Subject: Response to Request for Additional Information Letter No. 017
Sent Date: 8/28/2008 5:05:20 PM
Received Date: 8/28/2008 5:09:41 PM
From: Wanda.K.Marshall@dom.com

Serial No. NA3-08-086R
Docket No. 52-017
COL/GY

DOMINION VIRGINIA POWER
NORTH ANNA UNIT 3 COMBINED LICENSE APPLICATION
RESPONSE TO REQUEST FOR ADDITIONAL INFORMATION LETTER 017

Figure 9.2-201 Plant Service Water System Simplified Diagram

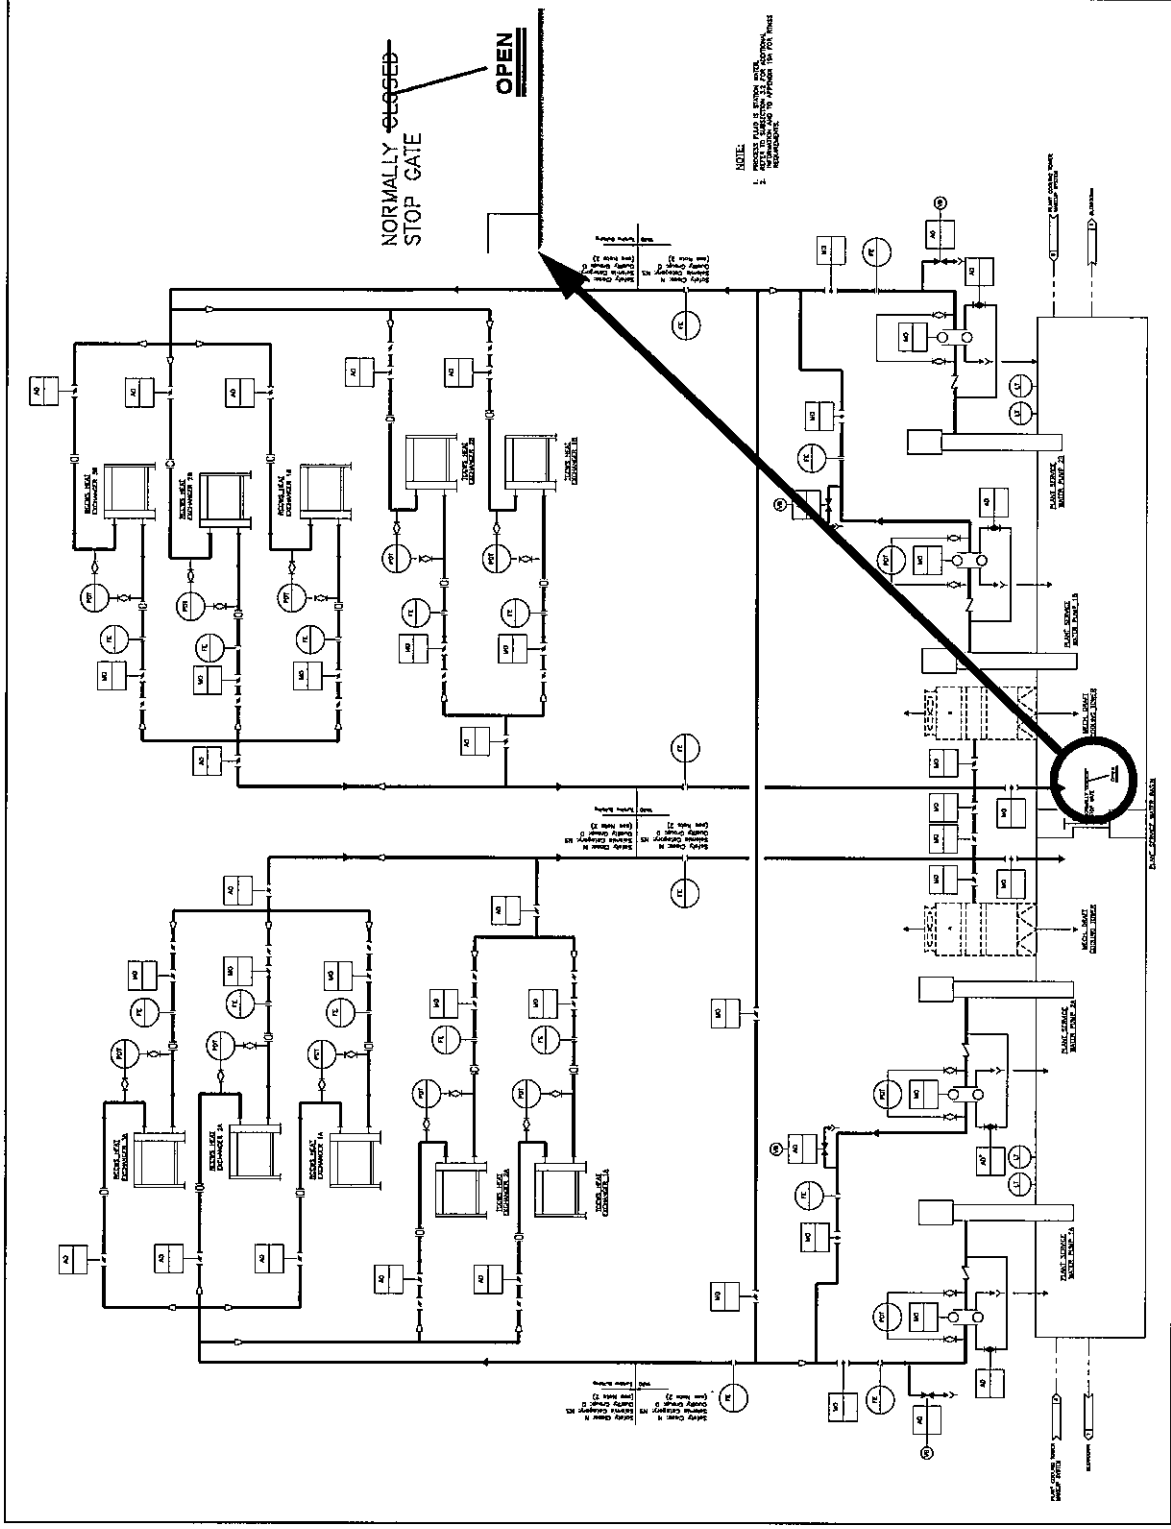
Tier 1 of the ESBWR DCD, Section 4.1, specifies as a COL interface requirement that the plant-specific PSWS be capable of removing 2.02×10^7 MJ (1.92×10^{10} BTU) over a period of seven days without active makeup. The proposed plant-specific ITAAC (Part 10: ITAAC, Table 2.4.2-1) specifies a cooling tower basin water inventory requirement as a way of demonstrating that the heat removal capability specified by the DCD has been satisfied. While water inventory is an important factor that must be addressed by the ITAAC, it does not demonstrate that the cooling towers are capable of dissipating the specified heat load. The capability of cooling towers to dissipate heat is dependent on a number of other factors that should be taken into consideration, such as cooling tower design attributes; the capability to satisfy the PSWS pump minimum net positive suction head (NPSH) requirements for the most limiting cooling tower basin water level, temperature, and flow conditions; the maximum allowed PSWS water supply temperature; and the most limiting meteorological assumptions that pertain to the site for determining: (a) heat dissipation capability, and (b) water inventory requirements. Transient analyses that take these factors into consideration (including margin for expected degradation and operating flexibility) and confirmatory testing are usually necessary in order to adequately demonstrate that cooling tower performance satisfies the specified heat removal requirement. Also, the basis and justification for using the combined cooling tower basin inventory for Trains and B were not explained and justified. Please revise the proposed ITAAC to include consideration of these factors such that the specified cooling tower performance capability is adequately demonstrated for both defense-in-depth and RTNSS functions, and revise the FSAR accordingly to fully describe the plant licensing basis in this regard.

Regarding the use of the combined cooling tower basin inventory from Trains A and B, the stop gate in the cooling tower basin is normally open, allowing the PSW pumps to draw water from the entire basin inventory. Figure 9.2-201 will be revised to indicate that the stop gate in the PSWS cooling tower basin is normally open to assure that the entire basin water inventory is available to meet the specified 2.6×10^6 gallon requirement.

FSAR Figure 9.2-201 will be revised as indicated in the attached markup.
